Access Compliance Report

Public Rights-of-Way

(Curb Ramps)

Intersection ID: 49933	Main Street: MARVIN_RD	Cross Street: WOBURN_RD	Location: SE
ADA ID: 3BC81A370E4C	Ramp Type: Perp	Initial Pass/Fail: Fail	Overall Compliance: No
Severity Score: 8.75			
Codes/Mitigation Info/Possible Solution		Field Measurements/Component Compliance

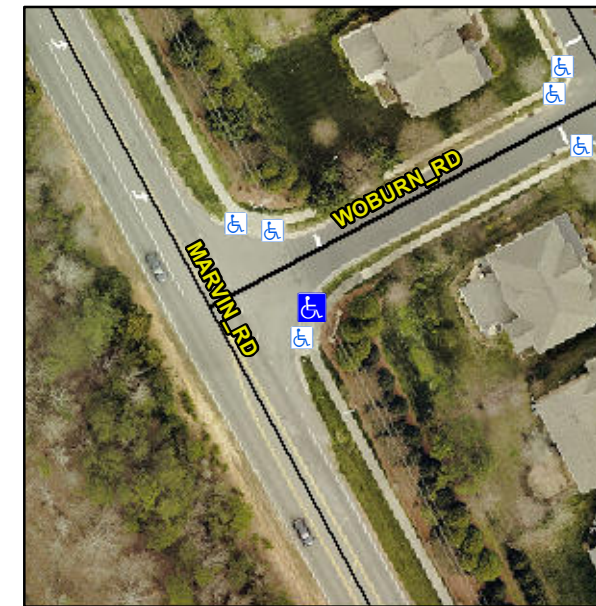
Not Found, R304.5.1

Compliance	Description	Data	Compliance	Description	Data
N/A	Ramp Length (in)	60.0	Yes	Ramp Slope (%)	5.1
No	Ramp Width (in)	46.0	Yes	Ramp XSlope (%)	0.1
N/A	Flare Type LT	N/A	N/A	Flare Type RT	N/A
N/A	Flare Slope LT (%)	N/A	N/A	Flare Slope RT (%)	N/A
N/A	Flare Traversable LT?	N/A	N/A	Flare Traversable RT?	N/A
N/A	Landing Length (in)	N/A	N/A	DWS Provided?	N/A
N/A	Landing Width (in)	N/A	N/A	DWS Contrast?	N/A
N/A	Landing Slope (%)	N/A	N/A	DWS Length (in)	N/A
N/A	Landing X Slope (%)	N/A	N/A	DWS Full Width?	N/A
N/A	Landing Curb? (Y/N)	N/A	N/A	DWS Offset (in)	N/A
N/A	Shared Landing?	N/A			
N/A	Gutter Ponding?	N/A	N/A	Gutter Slope (%)	N/A
N/A	Gutter Lip Ht (in)	N/A	N/A	Gutter X Slope (%)	N/A
N/A	Painted X Walk1?	No	N/A	Painted X Walk2?	N/A
	X Walk 1 Direction	To NW		X Walk 2 Direction	N/A
N/A	X Walk 1 Width (in)	N/A	N/A	X Walk 2 Width (in)	N/A
	X Walk 1 Slope (%)	7.2		X Walk 2 Slope (%)	N/A
	X Walk 1 X Slope (%)	2.7		X Walk 2 X Slope (%)	N/A

Remove & Replace Entire Ramp.
